FIRST FIVE-YEAR REVIEW REPORT
FOR
DEVENS RESERVE FORCES TRAINING AREA
DEVENS, MASSACHUSETTS

U.S. Army Corps of Engineers
New England District
Concord, Massachusetts

Harding Lawson Associates
Portland, ME
Project No. 45227
Task No. 0993804

**RESPONSE TO COMMENTS
ON THE DRAFT FIRST FIVE-YEAR SITE REVIEW REPORT
FOR THE DEVENS RESERVE FORCES TRAINING AREA
DEVENS, MASSACHUSETTS**

FIGURE
9-2

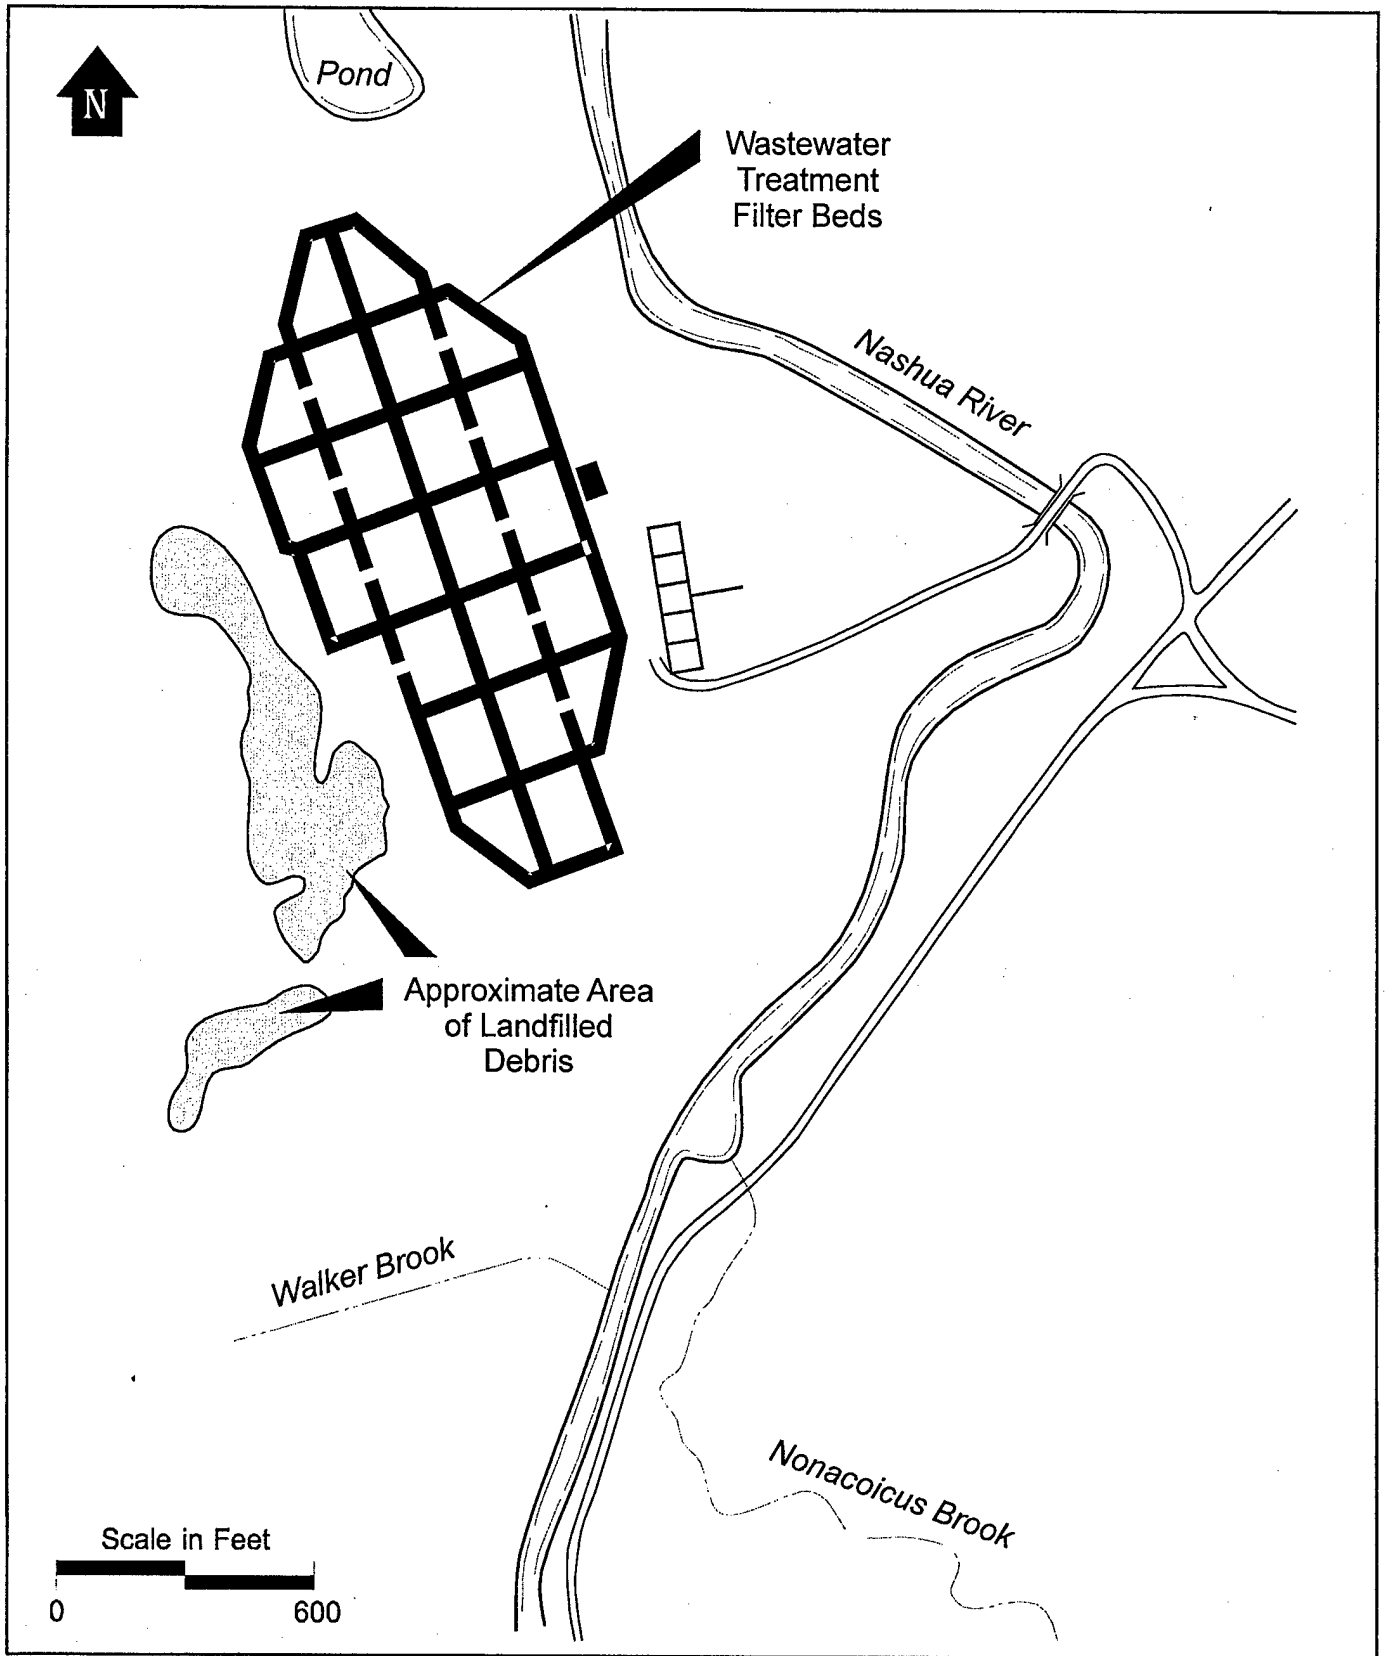
48. Comment: Figure 9-2 - *typo*: Change "Nashus River" label to "Nashua River."

Response: The requested spelling correction has been made to Figure 9-2.
